From: Scala, Mary Joy
Sent: Monday, March 21, 2016 3:30 PM
To: Powe, Gregory; Woodard, Keith
Subject: BAR Action March 15, 2016 – 200 2nd Street SW

RE: Certificate of Appropriateness Application

BAR 16-01-01
200 Second Street SW
Tax Parcel 280069000, 280071000-280075000
Powe Studio Architects, Applicant/Market Plaza LLC, Owner
Refinements to building and plaza and landscape design

**CITY OF CHARLOTTESVILLE
BOARD OF ARCHITECTURAL REVIEW
STAFF REPORT
March 15, 2016**

PLAZA EAST WALL: ORIGINAL DESIGN

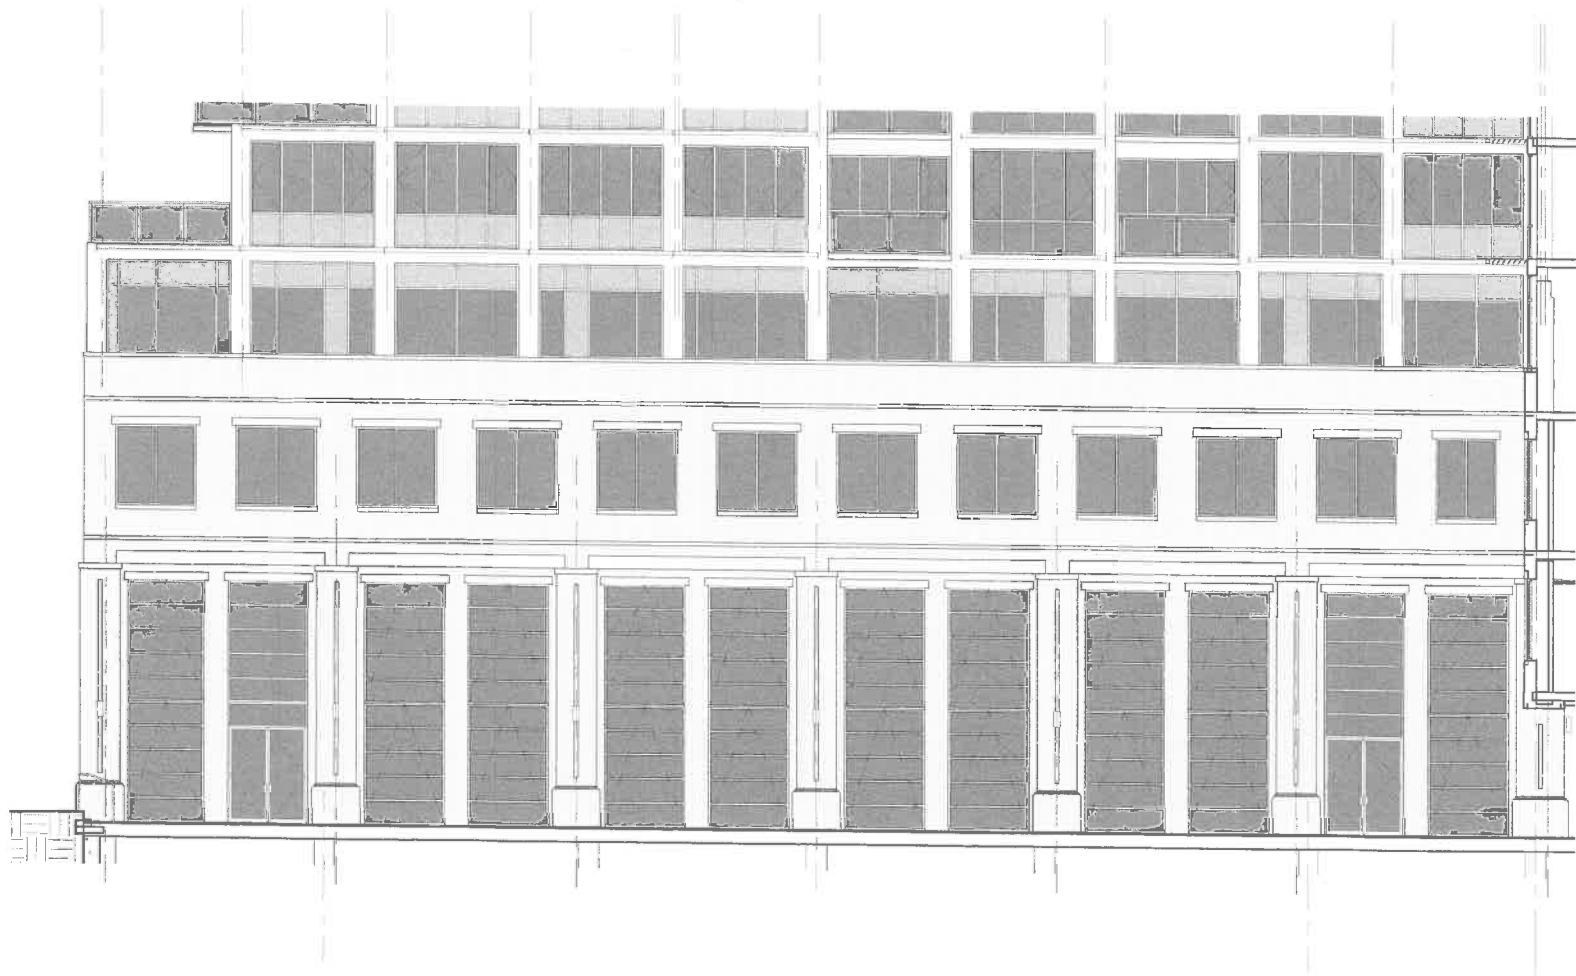
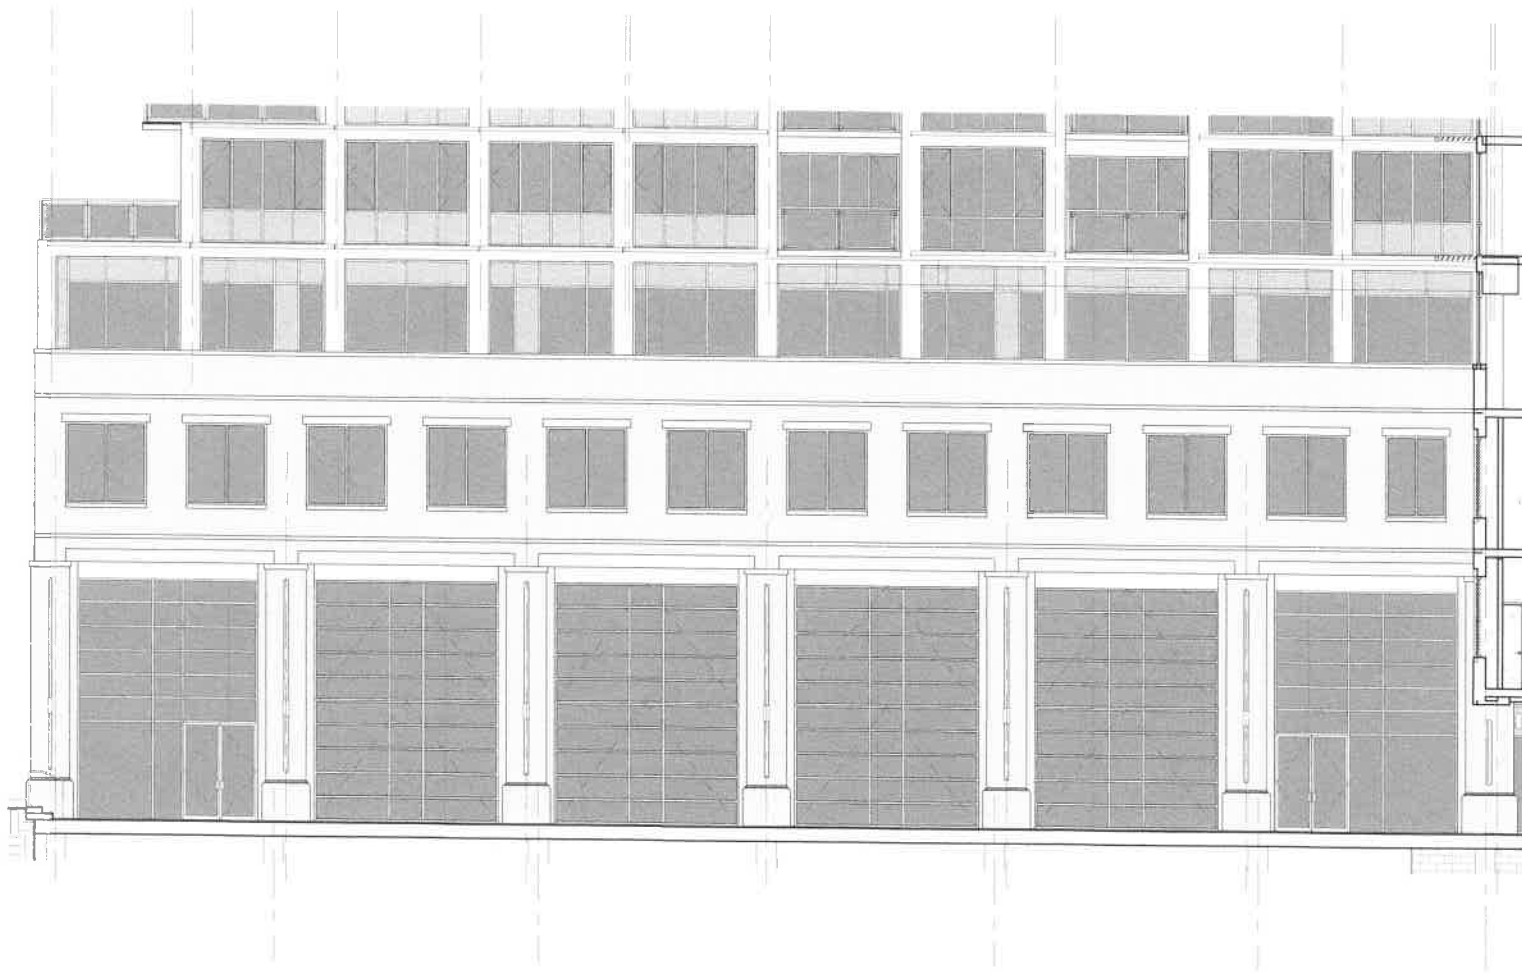
Further to our February 23, 2016 submission to BAR, we would appreciate adding this minor supplemental package of three additional items: an Owner requested plaza façade change as we refine the events space interiors, the exterior balcony light fixture (which we had omitted in the lighting package), and selected plaza bench.

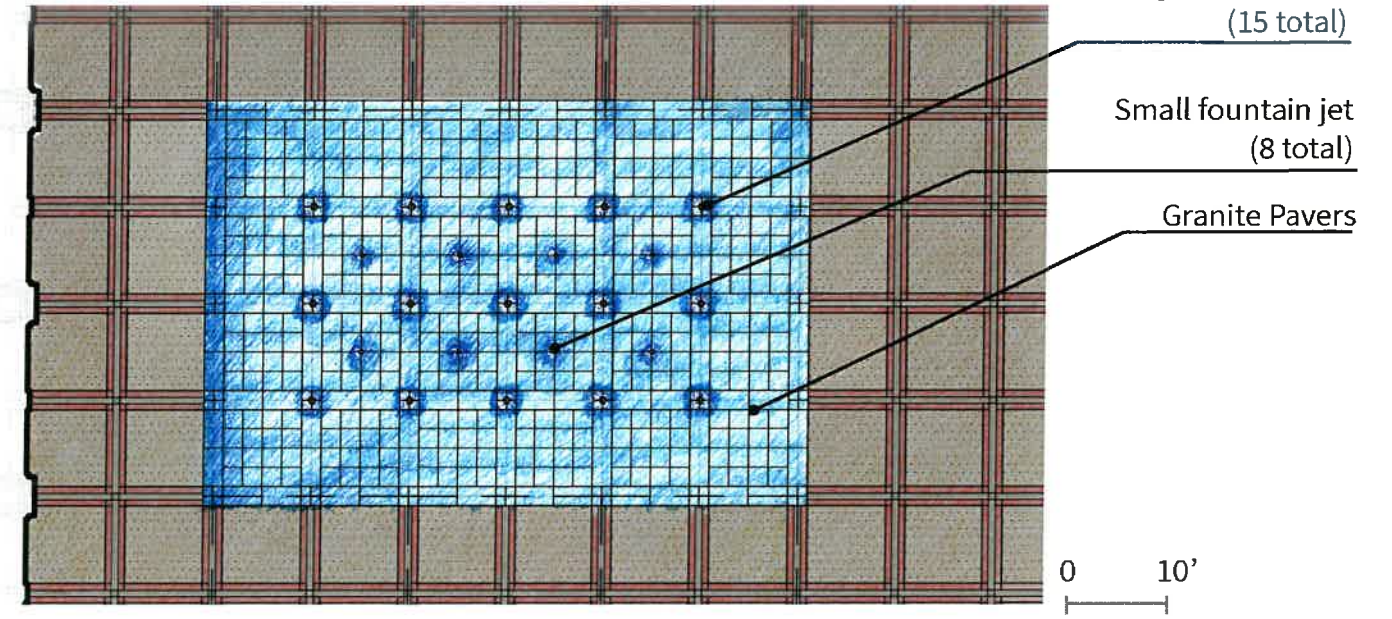
Residential Lobby Entrance: As the developer gears up to market the apartments, our residential marketing consultant has requested that we modify the "front door" street entrance into the residential lobby to provide a more distinctive identity. Our revised entry design (see attached existing and proposed renderings) is to retain the brick peers and glazed openings consistent with the remainder of the building, but to simply pull the entrance doors and entrance canopy forward 3 feet (we have 3 ½ feet to the property line) to provide a more prominent and distinctive primary residential entrance identity on Second Street, all contained within the original glazed opening, a careful balance between this important entrance identity and the overall building expression.

- **plaza material selection approved**
- **lighting package with controls approved as discussed, and preferably 2700K for light fixture 2 with the rest 3000K**
- **residential entrance to be revisited with other options**
- **plaza benches approved**
- **hanger doors approved**
- **roof top garden approved**
- **tree plantings approved**
- **design for the residential entrance to be circulated and approved via e-mail**
- **solar panels on the roof to be circulated and approved via e-mail**
